KC750 TO KW11-K

DECOLOG Engineering Change Order Log

FIELD CHANGE ORDER

FCO KC750 P 0001 PAGE 1 of 13

Fig. 2

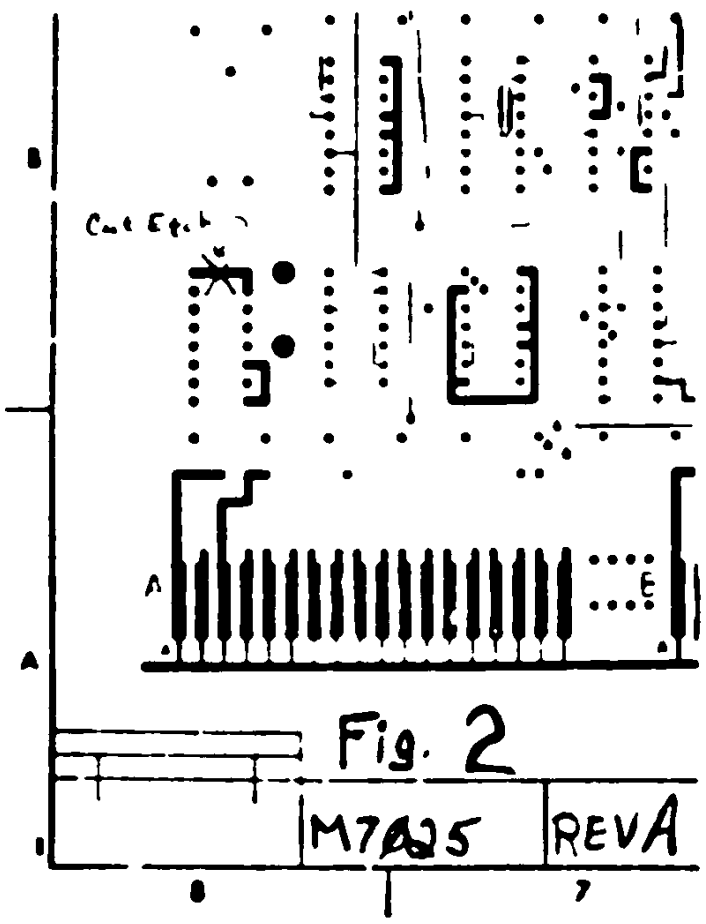
1. Remove Crystal Y1
2. Remove IC Chip E1 (745124).
3. Cut etch side 1, between E1 pin 7 and E3 pin 11.
4. Cut etch side 2, between E1 pin 16 and E1 pin 1. (See Fig. 2)
5. Add wire between E1 pin 10 and E3 pin 11.
6. Add wire between E1 pin 9 and E1 pin 7.
7. Insert 20 MHZ oscillator pack in E1 chip.
